June 1, 2021

**ADDENDUM NO. 1**  
**TO CONTRACT DOCUMENTS FOR THE**  
**RINCONADA WATER TREATMENT PLANT (RWTP)**  
**RESIDUALS REMEDIATION PROJECT**  
**Project No. 93294058 Contract No. C0671**

**ADDENDUM NO. 2**  
**TO CONTRACT DOCUMENTS FOR THE**  
**RINCONADA WATER TREATMENT PLANT (RWTP)**  
**RESIDUALS REMEDIATION PROJECT**  
**Project No. 93294058 Contract No. C0671**

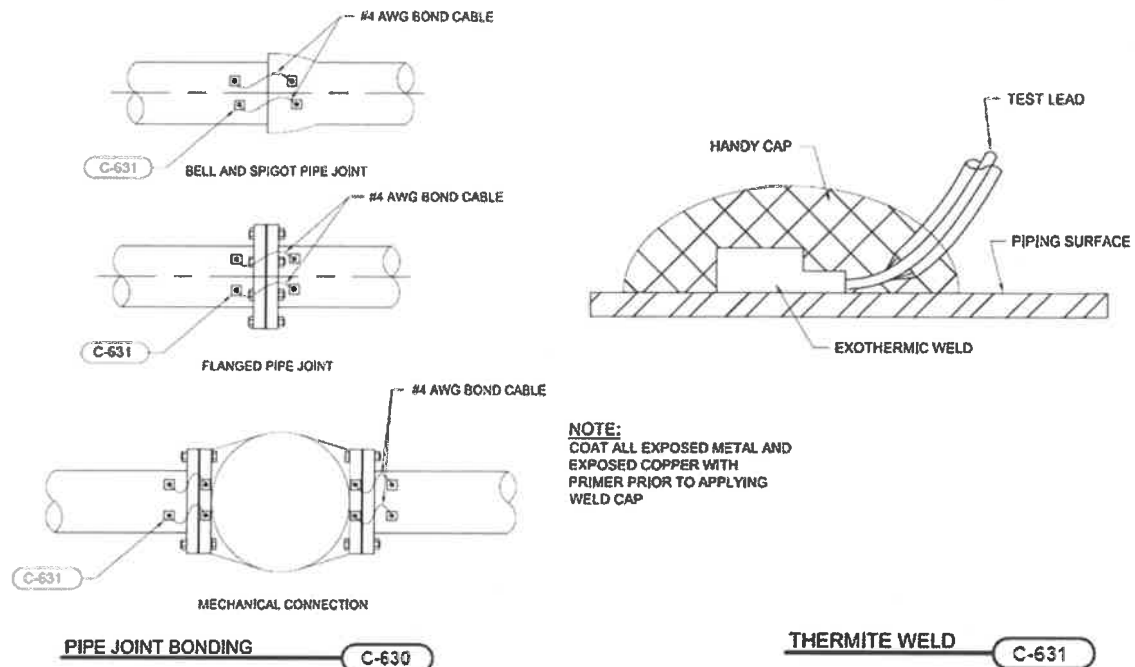
Specification section 33 92 20 Ductile Iron Piping 2.01 "G" states "Pipe joints shall be prepared for bonding electrical conductivity in accordance with the details indicated. Contractor Shall furnish materials required for joint bonding and electrolysis test station installations." Specification section 40 05 00 Paragraph 2.09 says metallic buried piping shall have bonded joints so that it may be cathodically protected in the future if necessary." Please clarify whether we need cathodic protection as the drawings do not call out any cathodic test stations. If so, please provide a detail and confirm that only jumpers are required at buried ductile joints for bonding.

Electrically bonded joints shall be provided per Standard Details C-630 and C-631 below. Cathodic protection is not required.

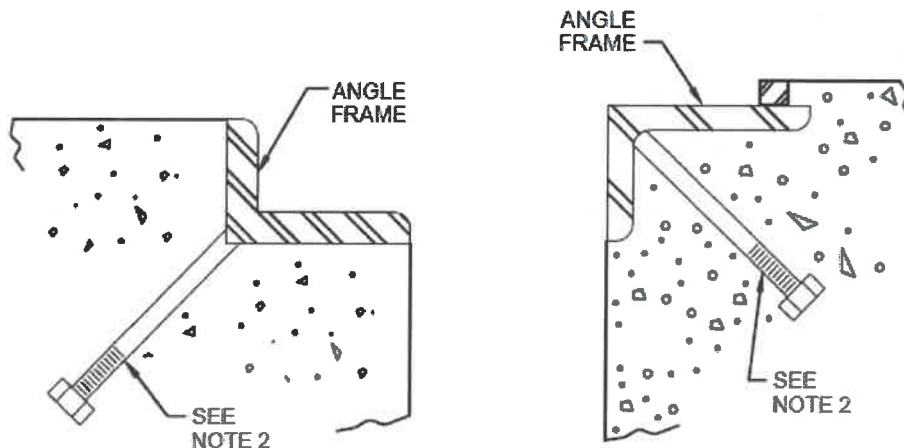
29. **REPLACE** Article 2.01. General, paragraph D.4.b for the following:

“b. Thermal flow switch **and high pressure switch** shall be provided on pump discharge or integral to the pump stator.”

**ALUMINUM WELDED STUD**

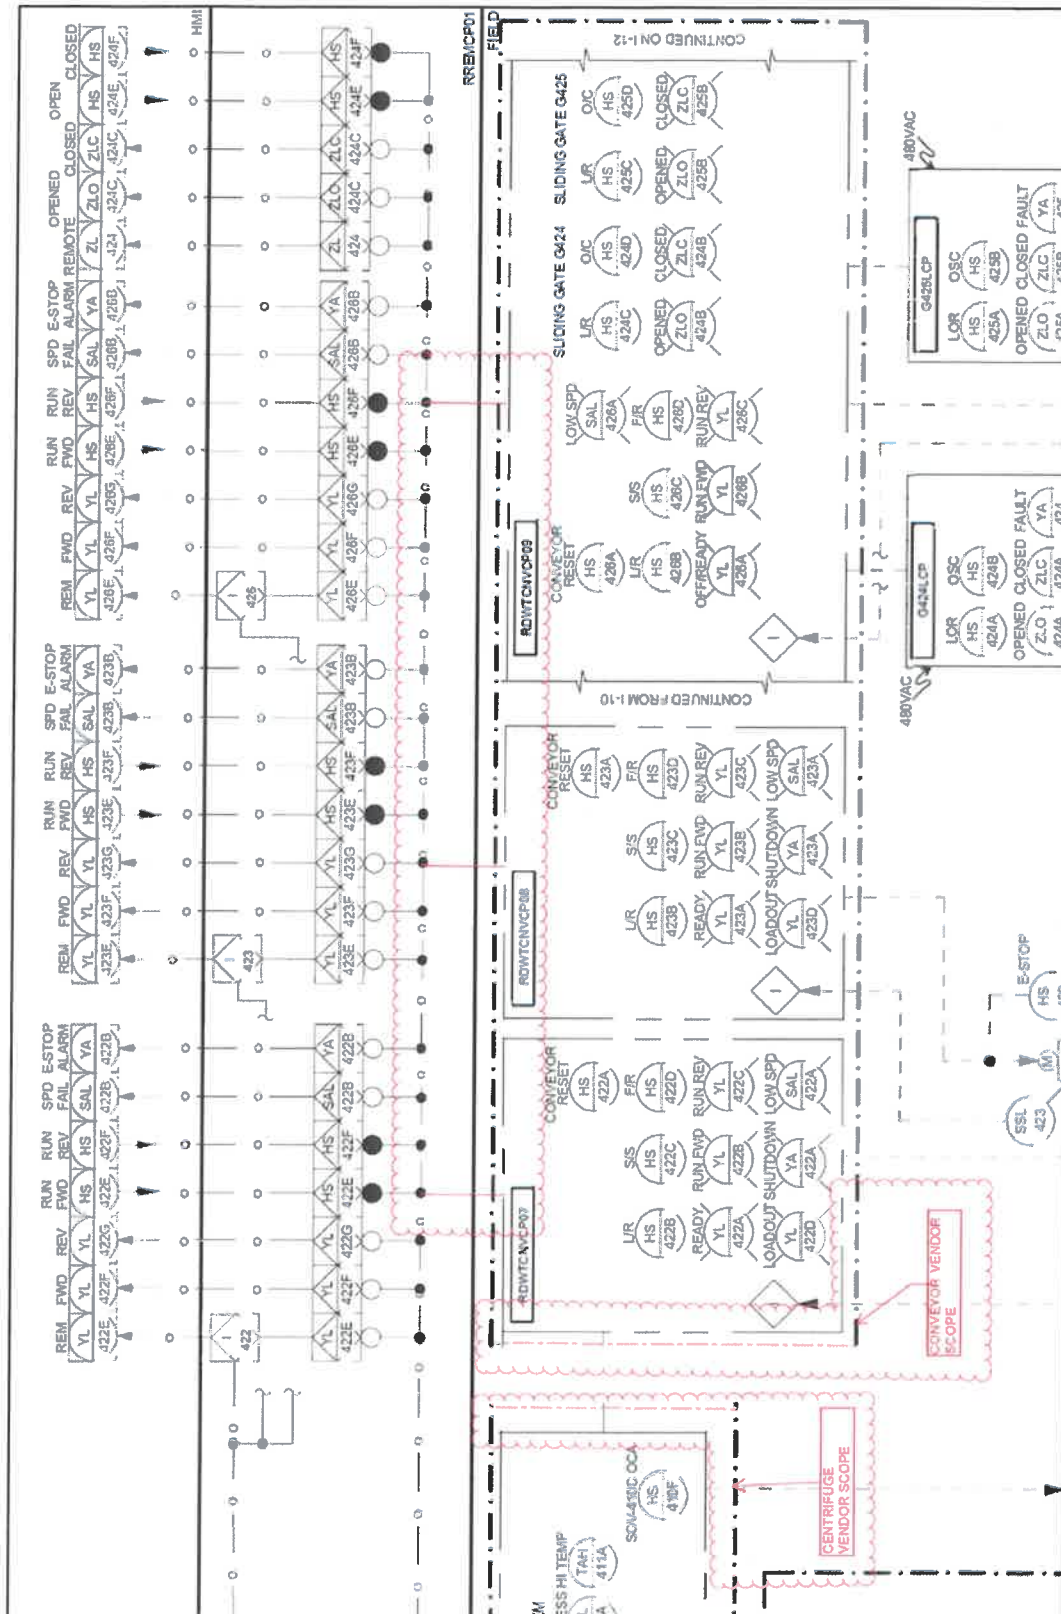
31. **ADD** Standard Detail S-504 to Sheet GS-9 as shown below.

SECTION C POLYMER LINES  
3M-5 NTS

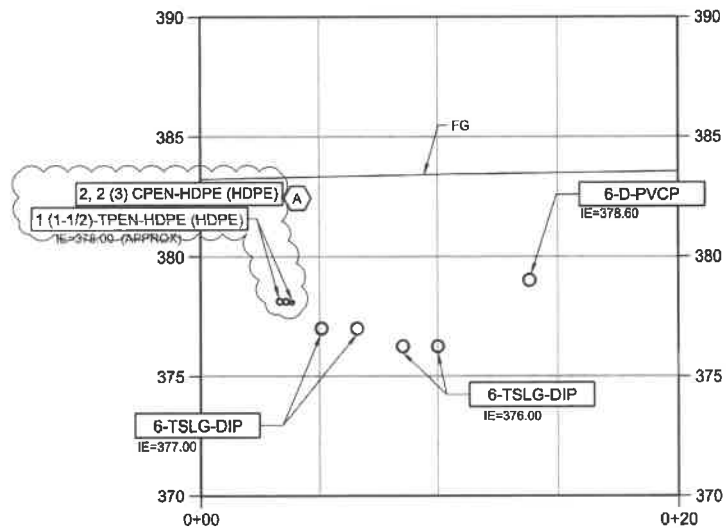
ATTACHMENT NO. 1 - LEAK DETECTION FOR THE CPEN AND TPEN YARD PIPING

PARTIAL PLAN C-YP-2 LOW POINT  
LEAK DETENTION PIPE UPDATE

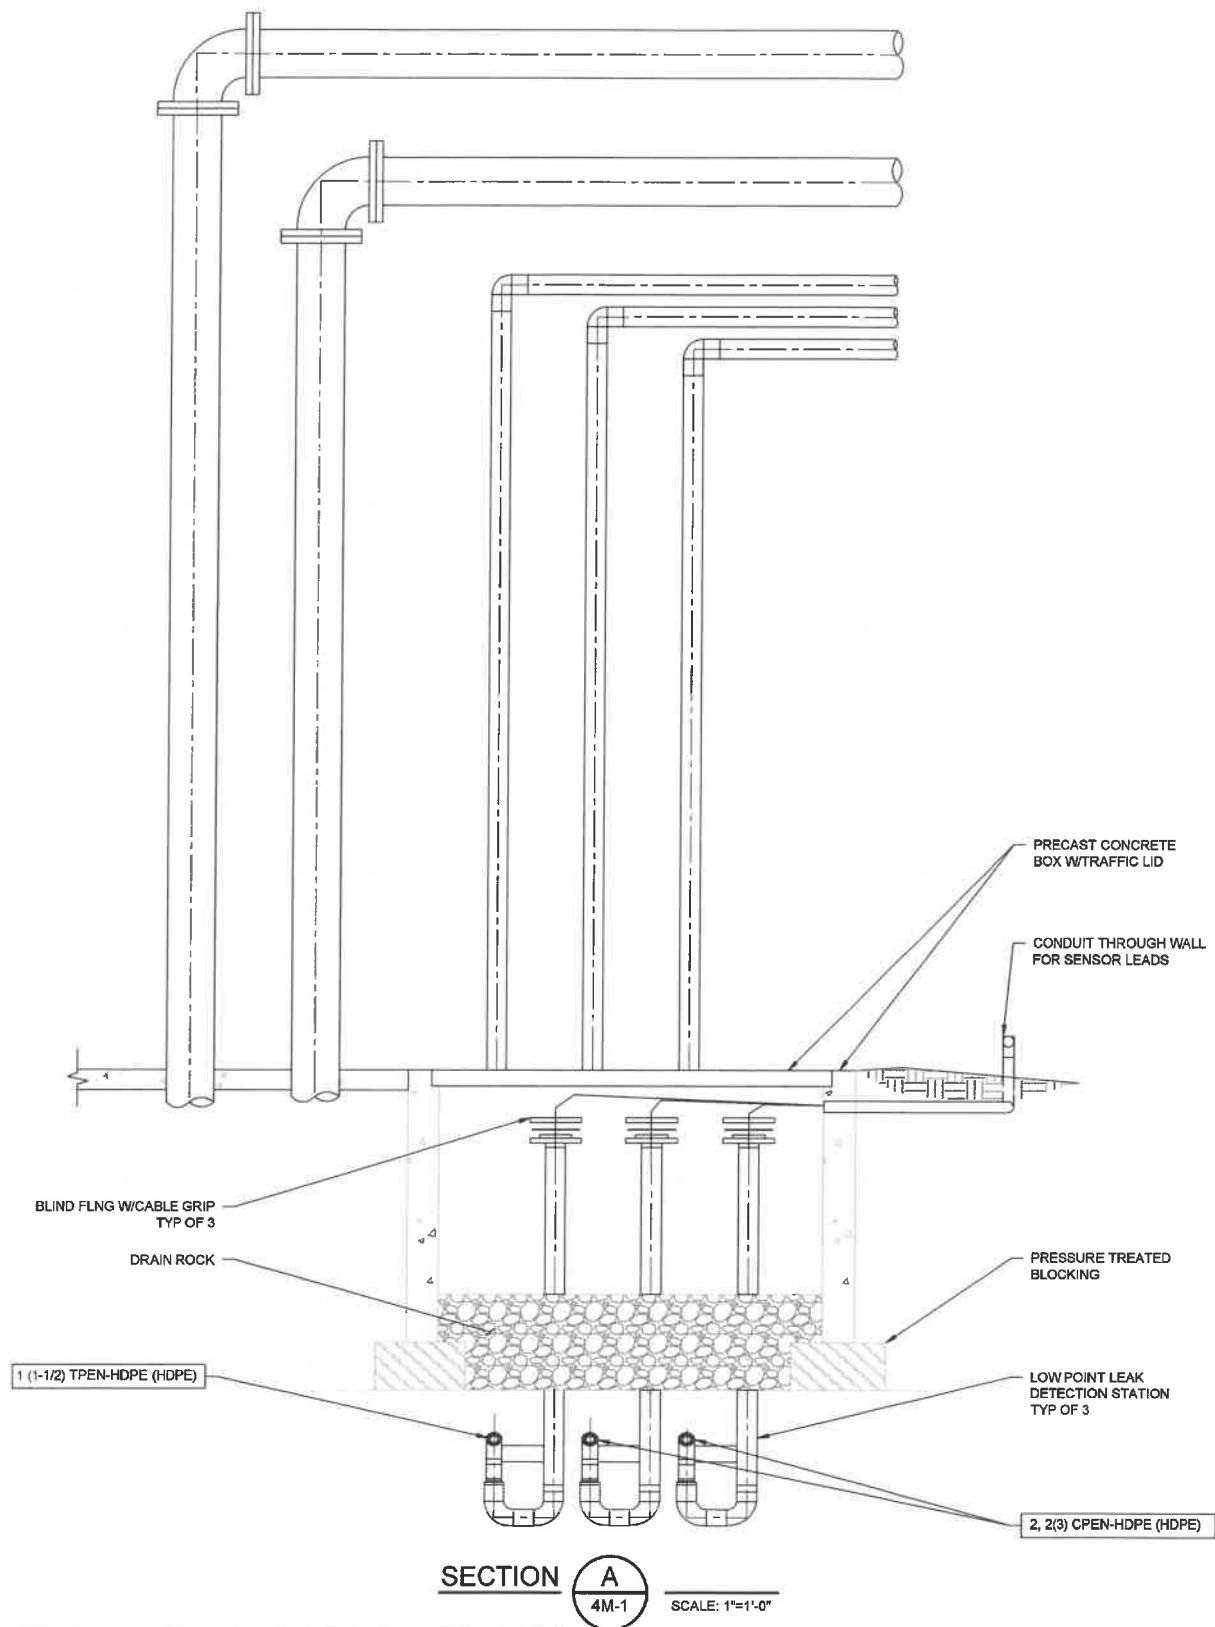
1. THE CPEN AND TPEN PIPE SHALL SLOPE TOWARD LEAK DETECTION VAULT WITH A SLOPE OF AT LEAST -0.5%

1. PIPE INSTALLER TO PROVIDE LOW POINT LEAK DETECTION STATION AS SPECIFIED.
2. PIPE INSTALLER TO PROVIDE BUND FLANGE WITH CABLE GRIP FOR SENSOR LEAD.
3. SLOPE THE TPEN AND CPEN TO A LOW POINT AT THE LEAK DETECTION POINTS.
